**City of Bellevue**  
**Department of Planning and Community Development**  
**Land Use Division Staff Report**

Proposal Name: **Pacific Regent II**

File Number: **06-112898-LD**

Decisions Included: Process II, Design Review with SEPA

# Tower One Upgrades

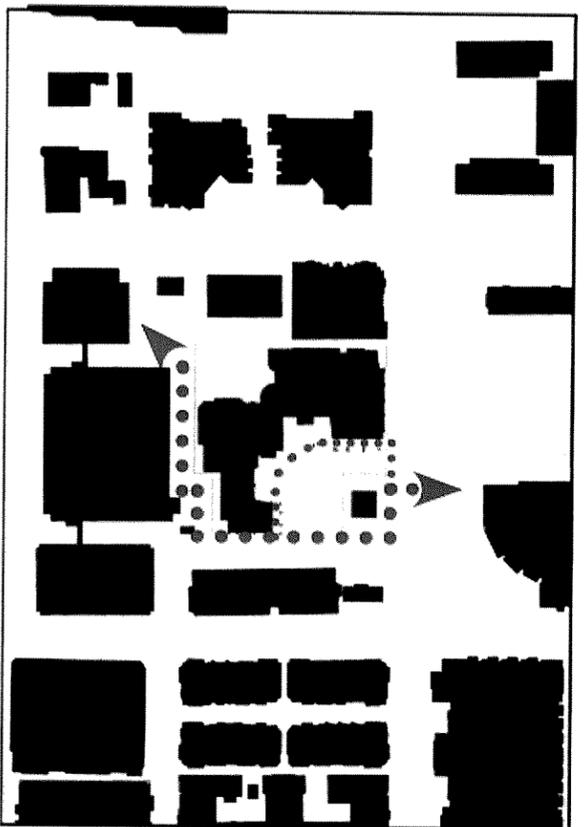
The existing tower was initially to remain unchanged; but the proposal was revised to unify the parapet and mechanical equipment screen in order to update the overall design of the building, improve its relationship to the proposed building and its signature on the Downtown skyline. The exterior color was also revised. The podium design will be redone for consistency with the look of the new building. Together these changes will help achieve a visually cohesive project.

Color and finish of new parapet wall in Tower One to match pre-cast in Tower Tower

Traffic Sight Triangles

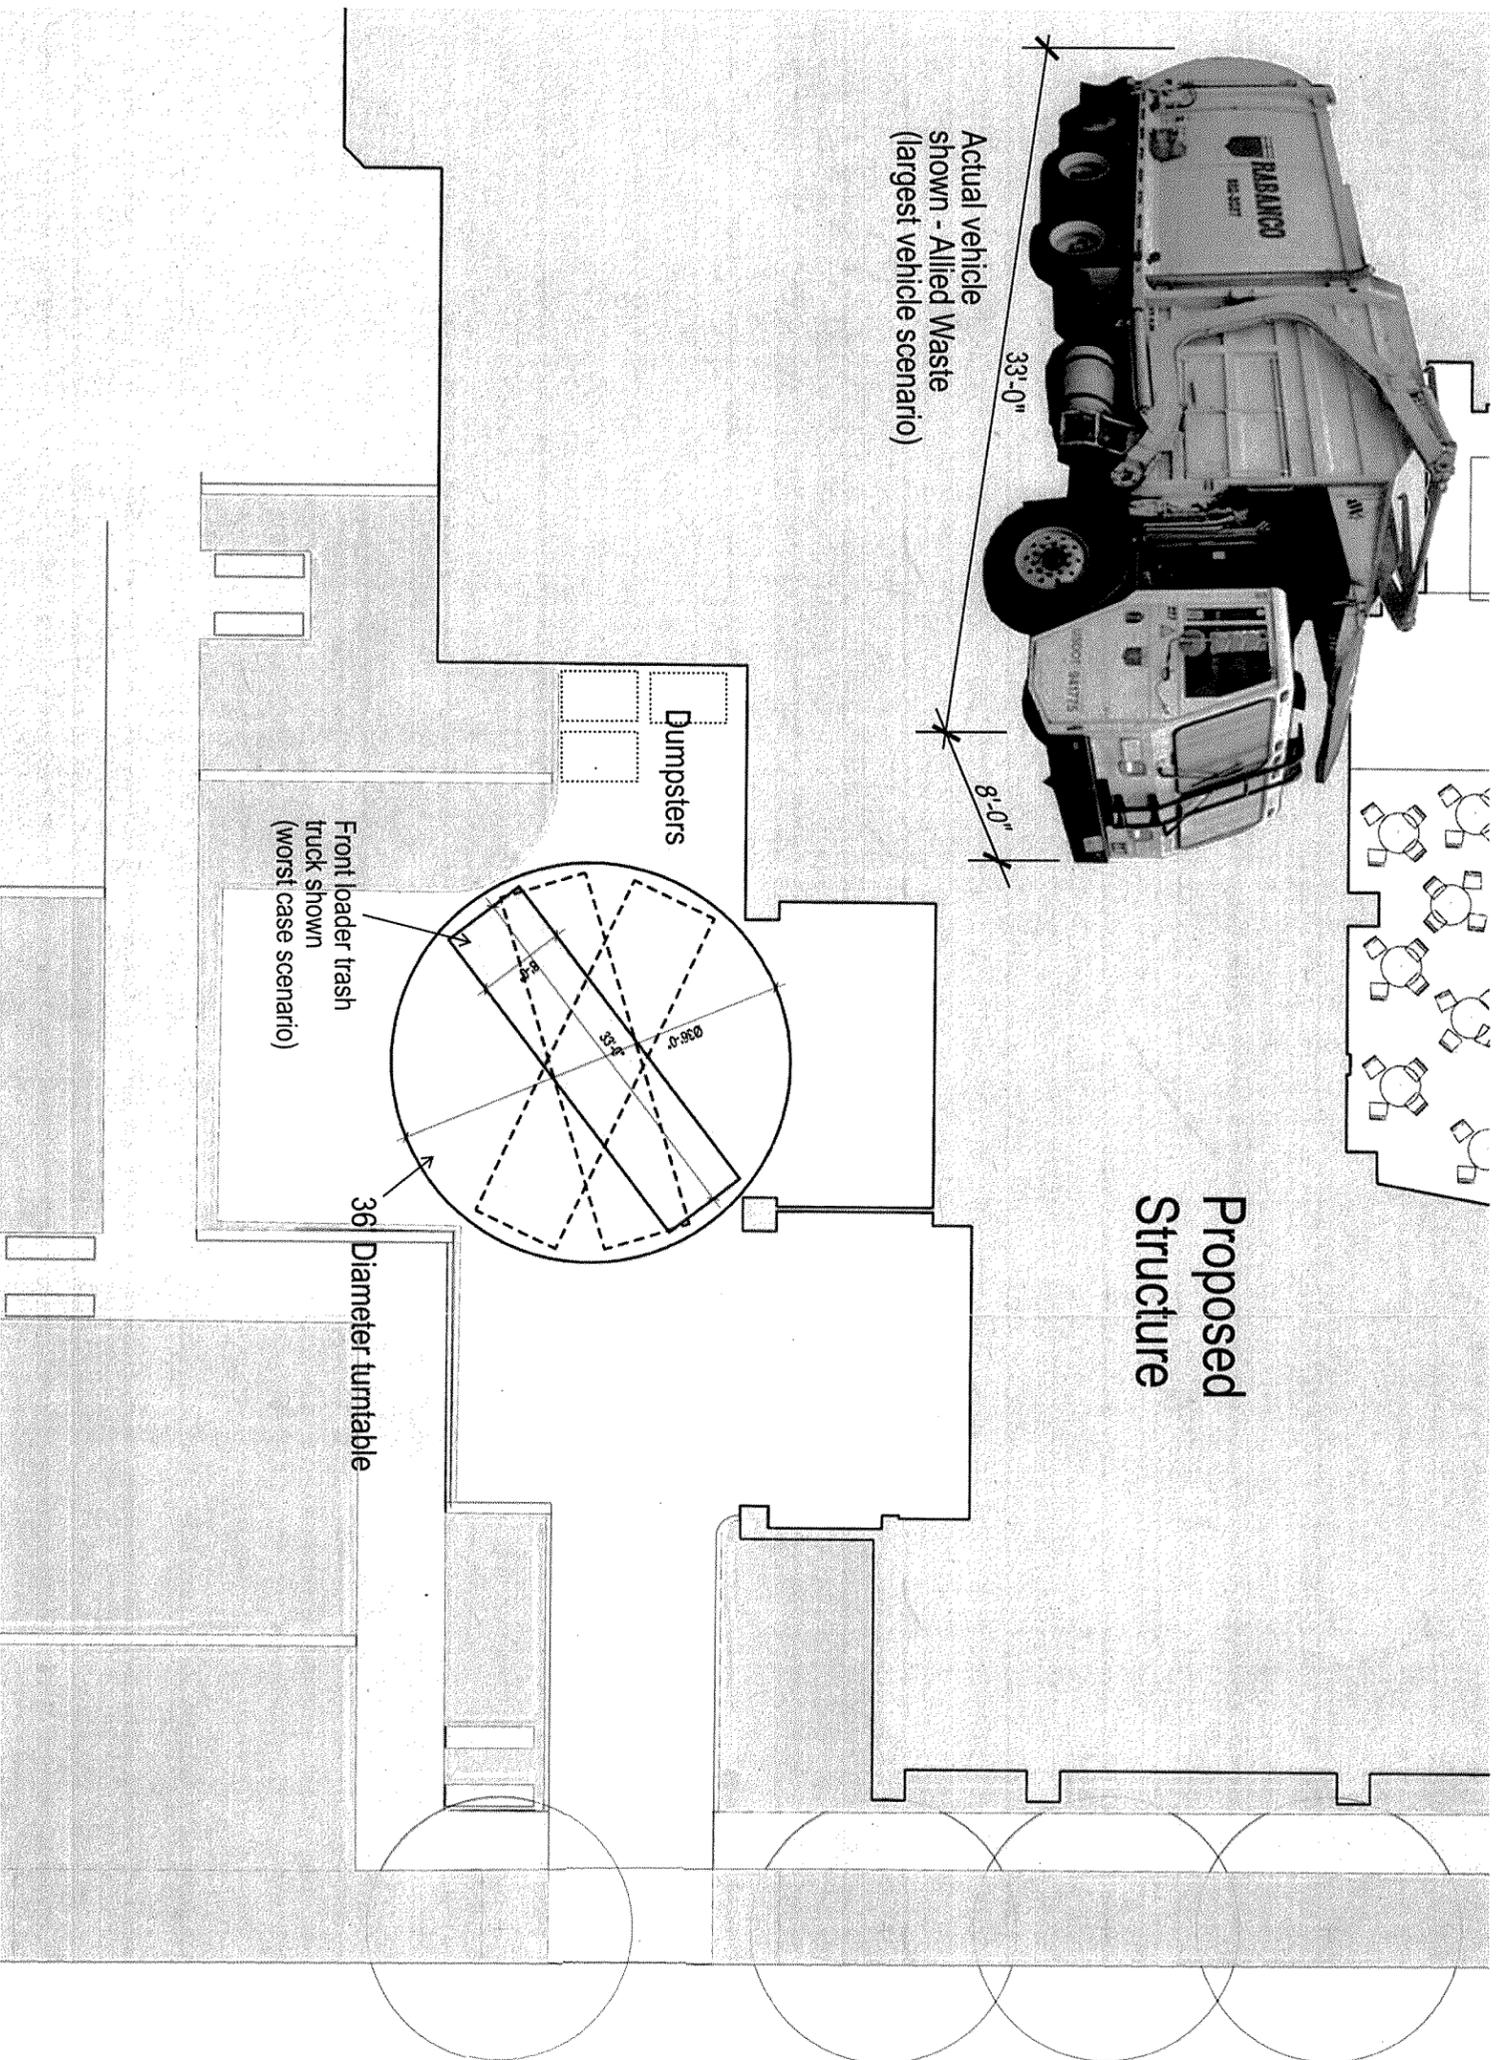
**1. Comment:** The City's decision should require adequate sight distance between service vehicle drivers exiting to NE 10<sup>th</sup> Street and pedestrians.

**Response:** Pedestrian sight distance to the west from the service driveway on NE 10<sup>th</sup> Street is difficult to achieve due to the corner of the neighboring building. The developer will be required to install warning signs and pavement markings as needed to guide vehicles

Access study G: Service truck turnaround at East delivery bay

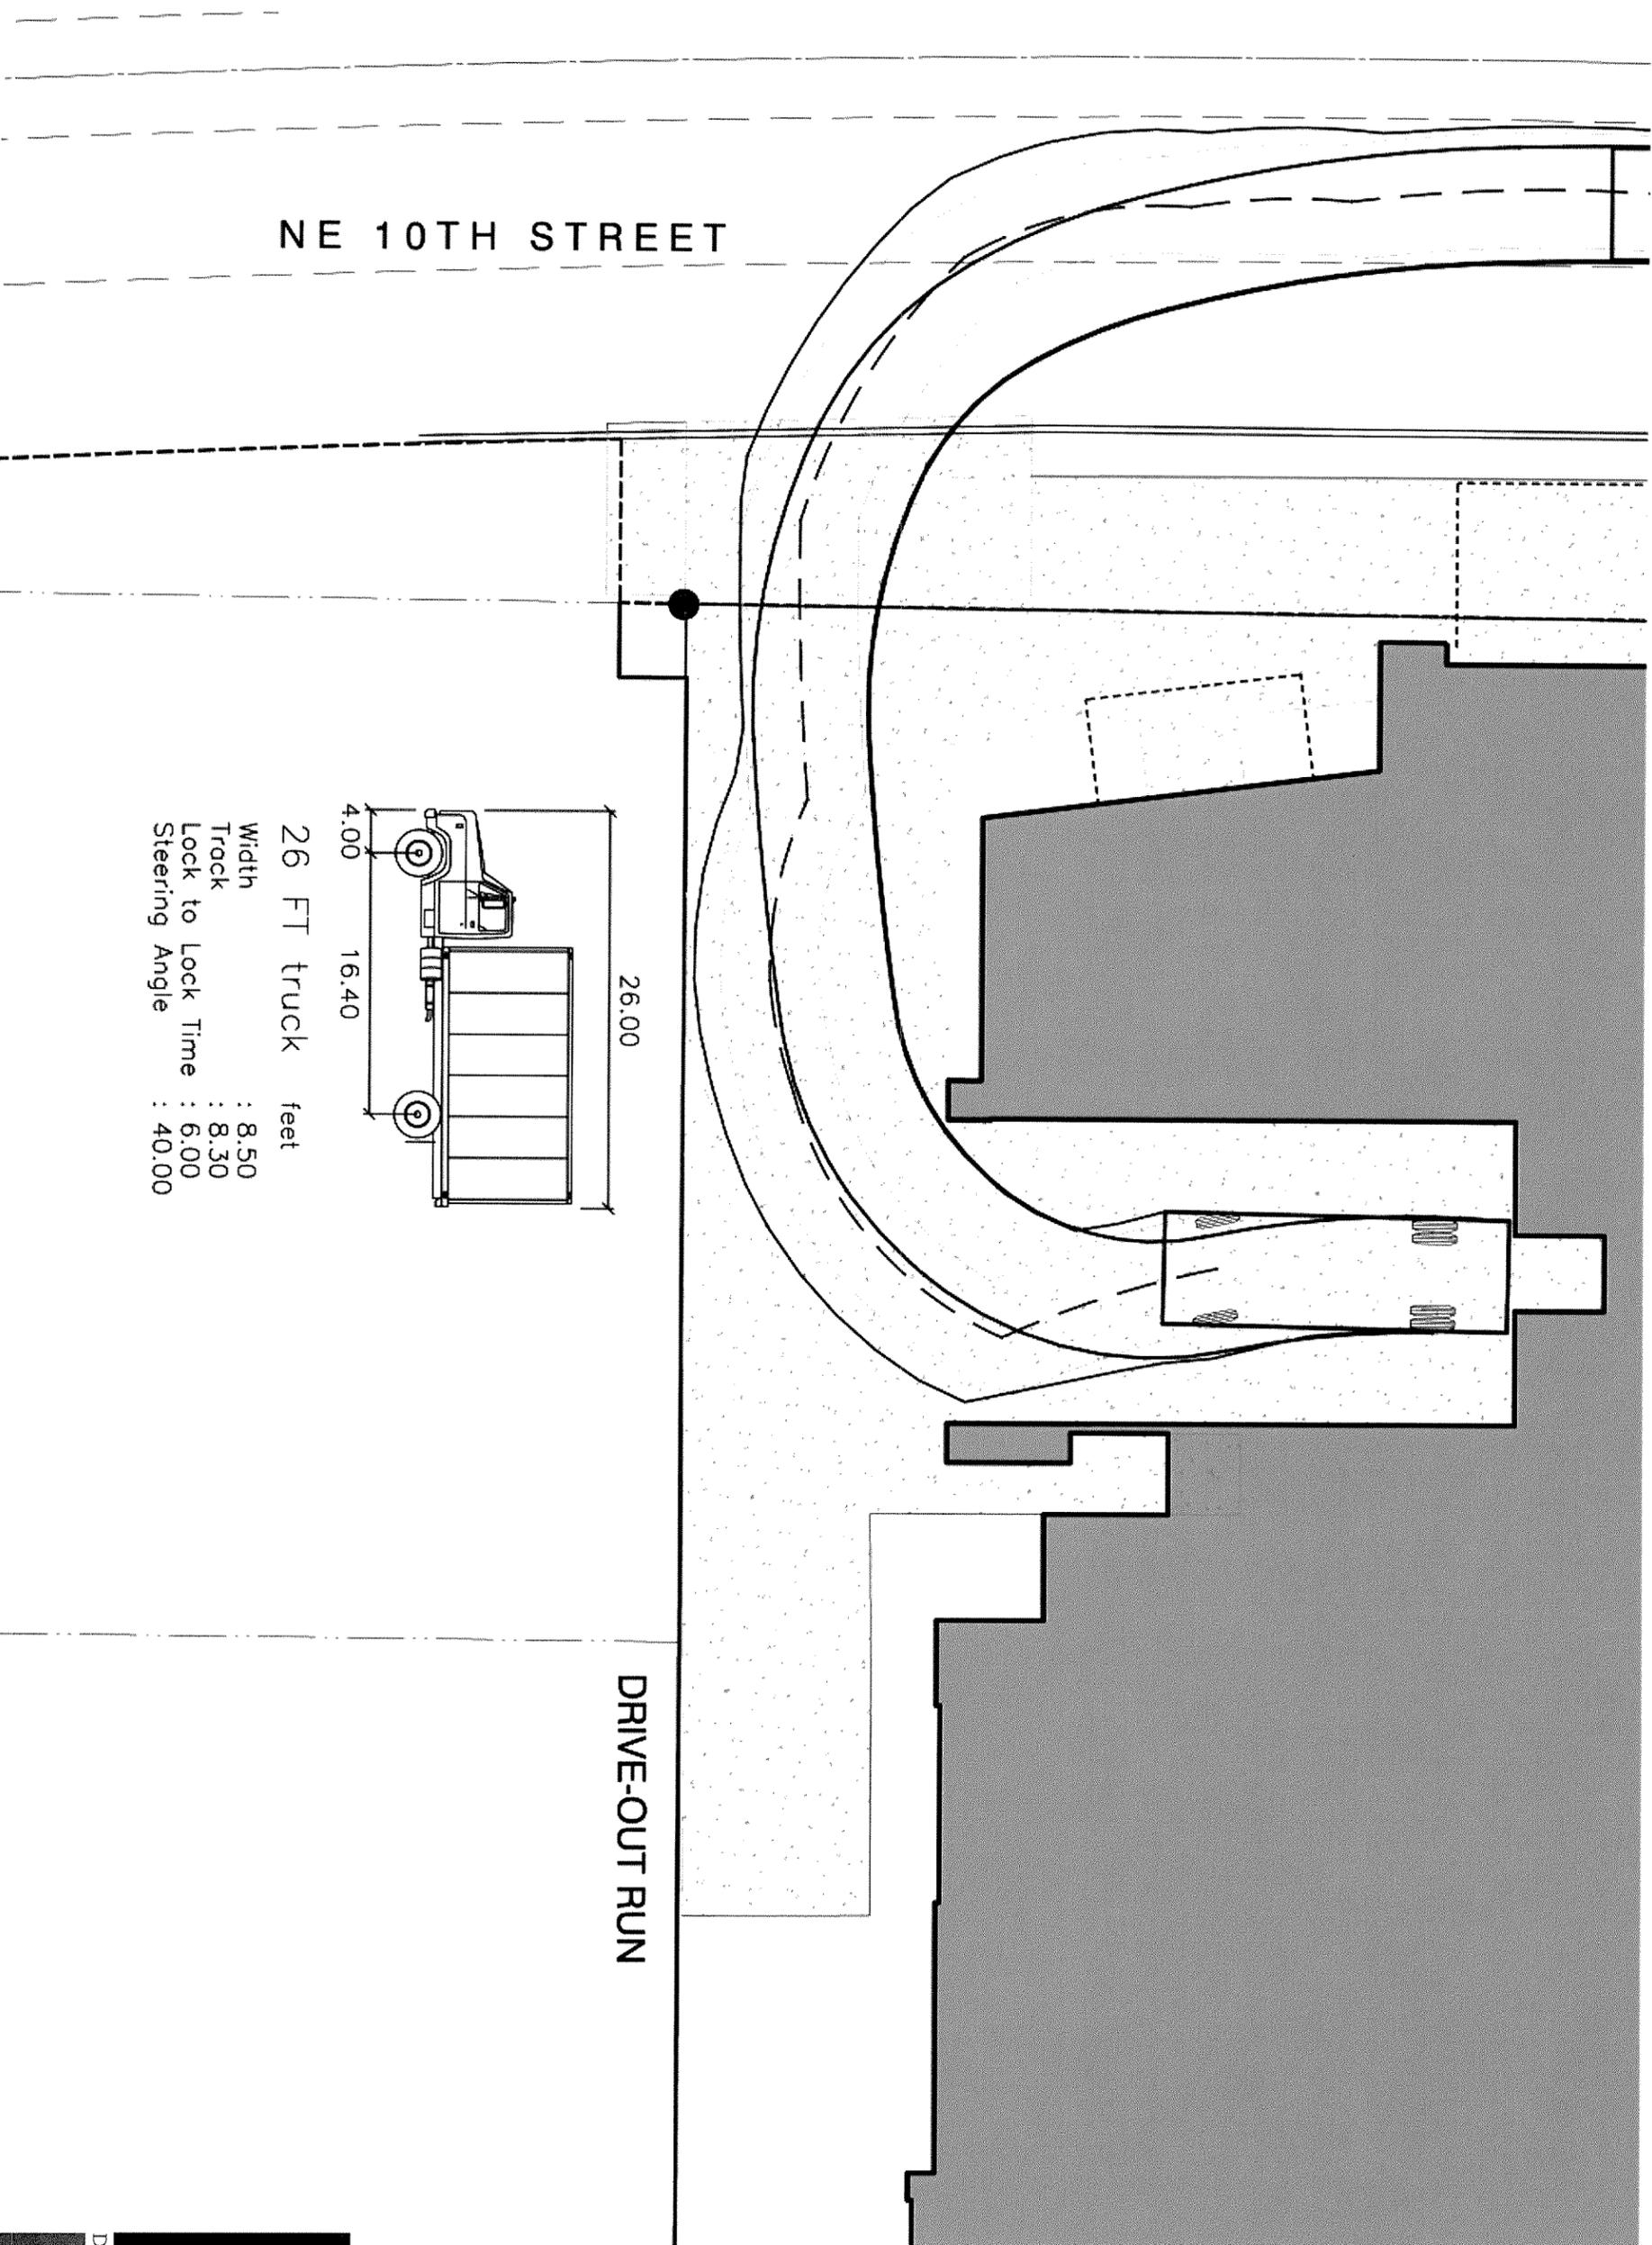
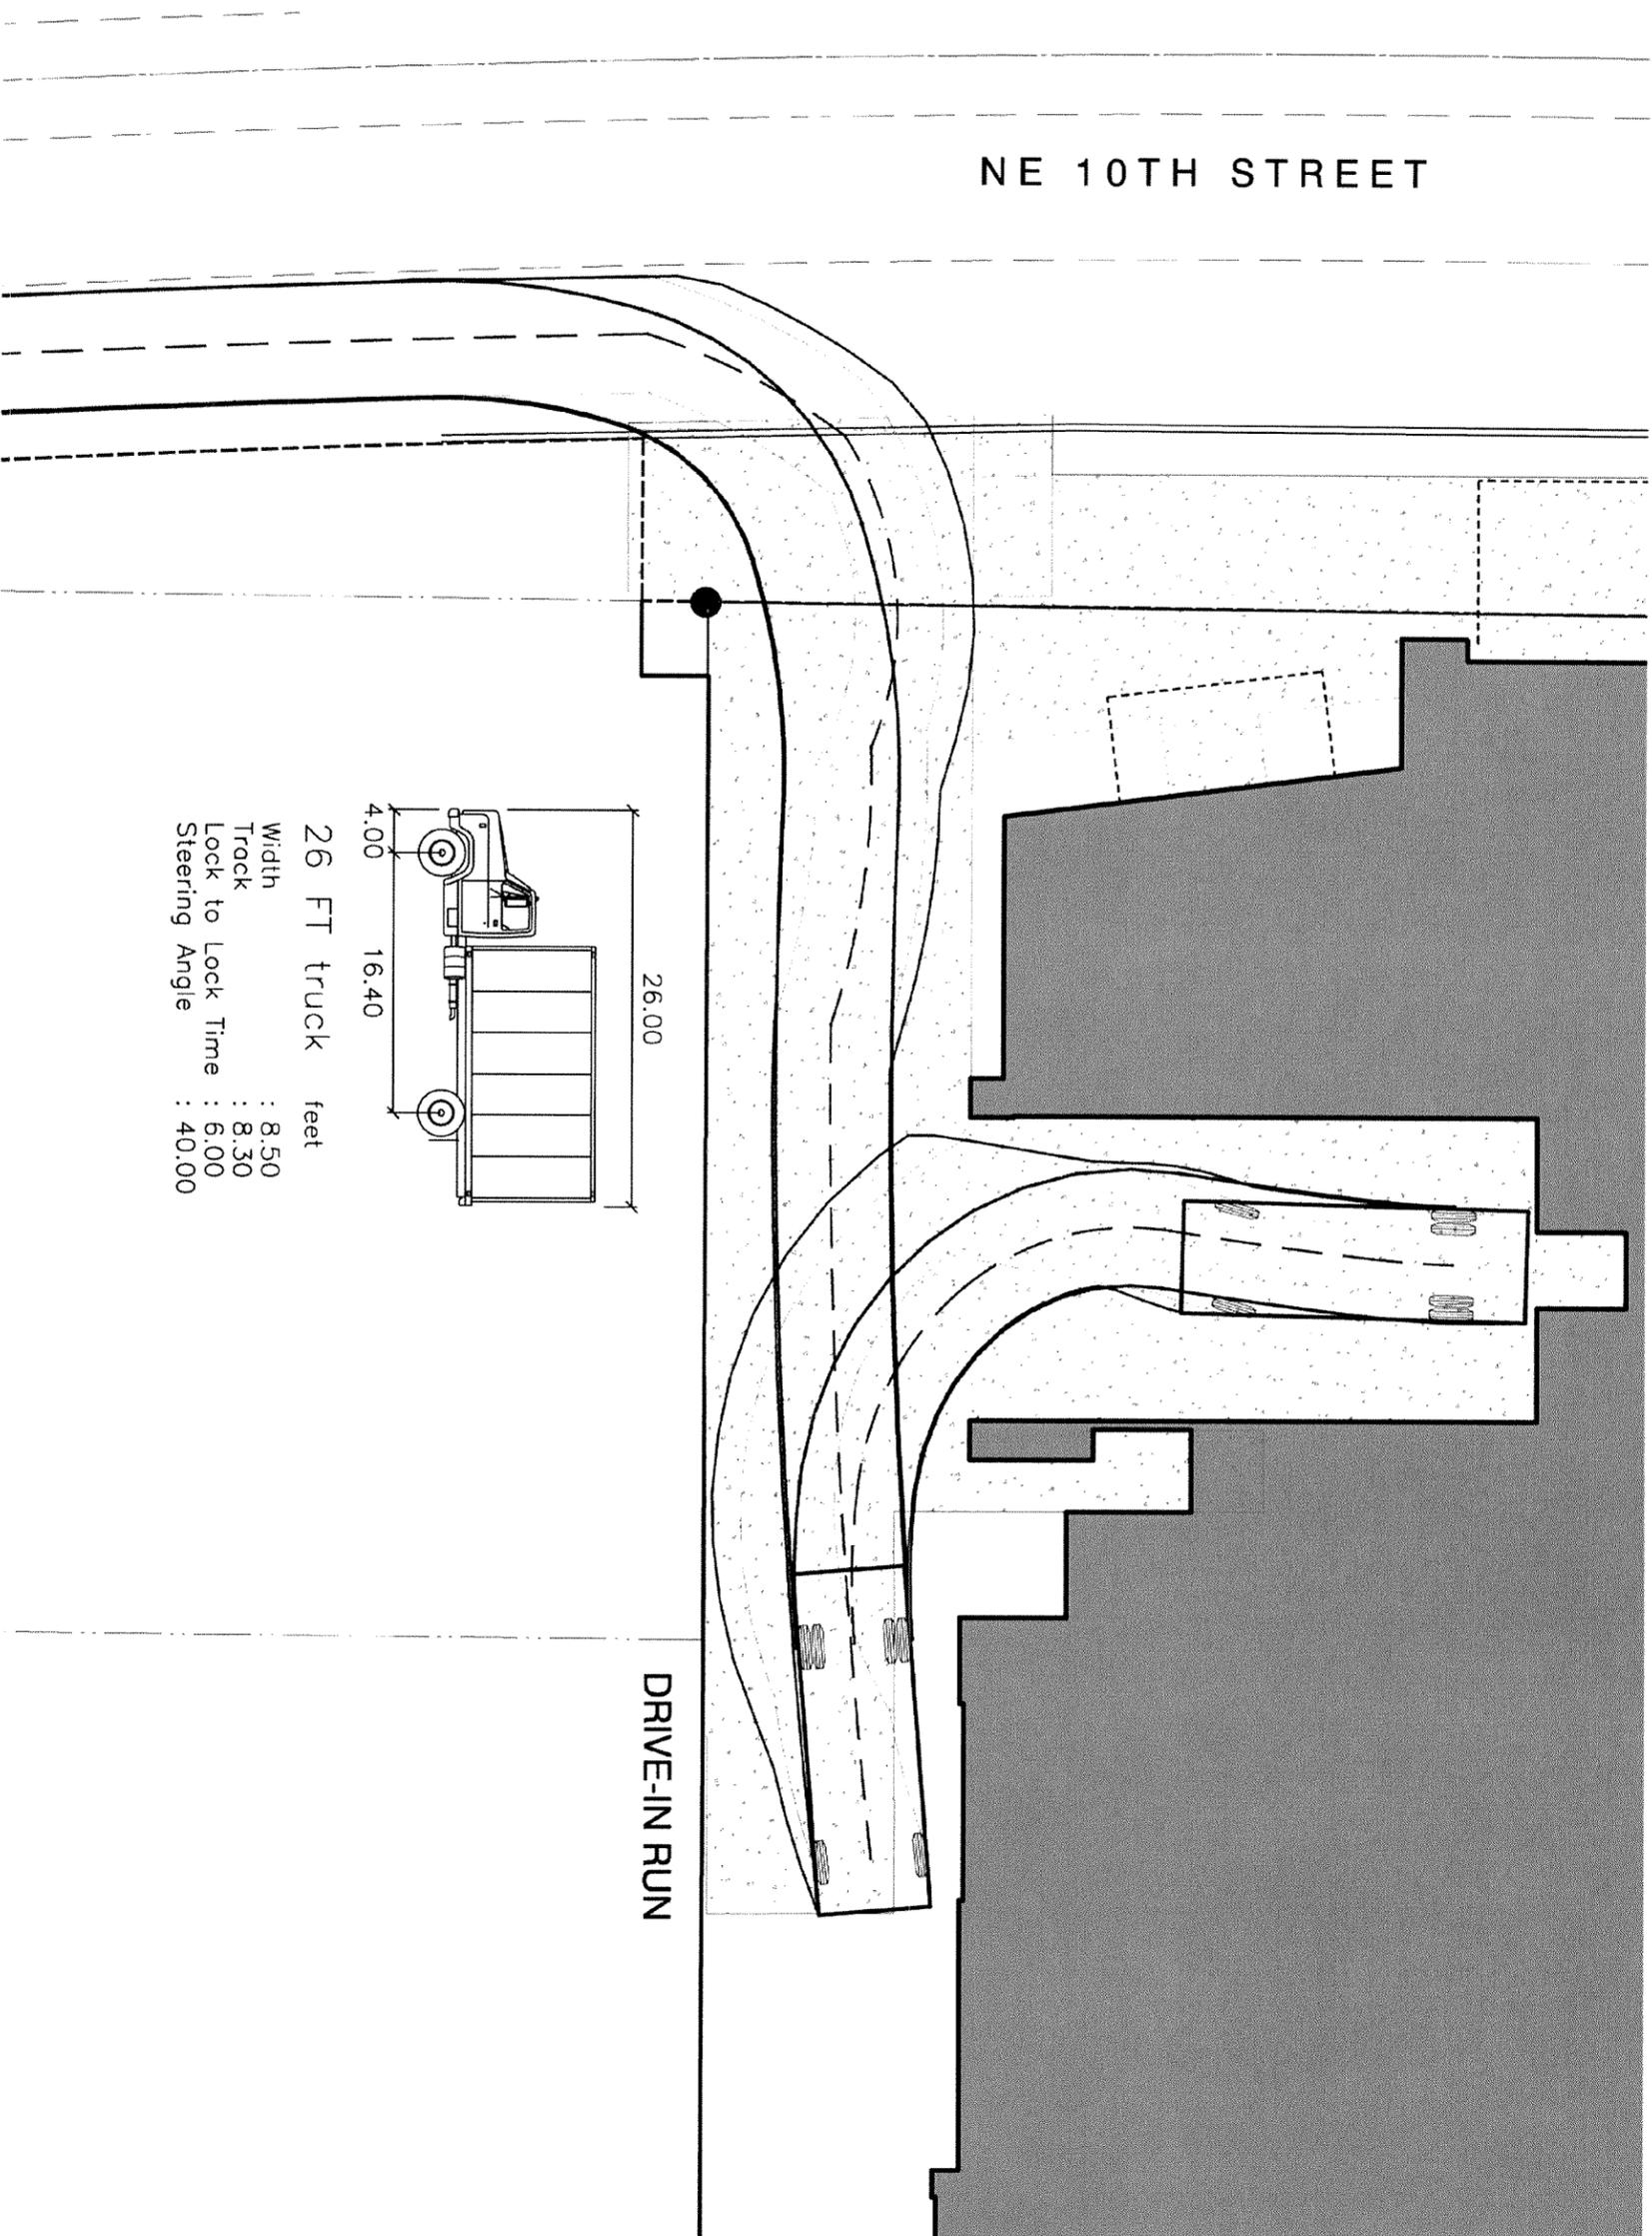
**3. Comment:** The City's decision should limit service vehicle length to 30-feet, and prohibit service vehicles from backing into traffic on NE 10<sup>th</sup> Street.

**Response:** Because the proposed service driveway on NE 10<sup>th</sup> Street will be very constricted, the City will require the developer to implement a policy to ensure that trucks longer than 26 feet do not use this driveway. Existing City code (BCC 14.60.150) prohibits approval of driveways where backing out of commercial vehicles would occur.
